ONX-C01 Rev B View L-L
Aft Rudder Cable Pulley
Installation
Scale 1:2

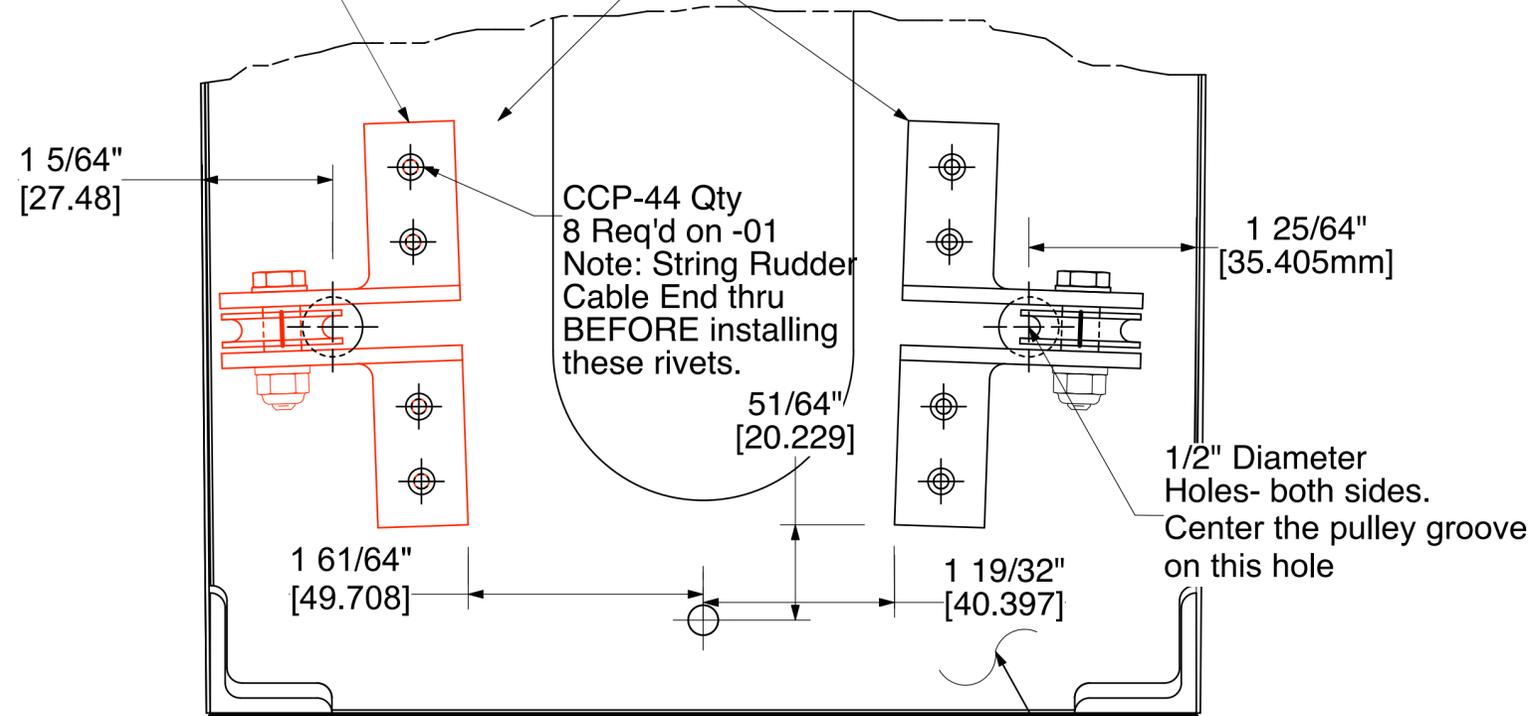
Moved the RH
Pulley Assembly Outboard
by 0.367" (New location in Red)
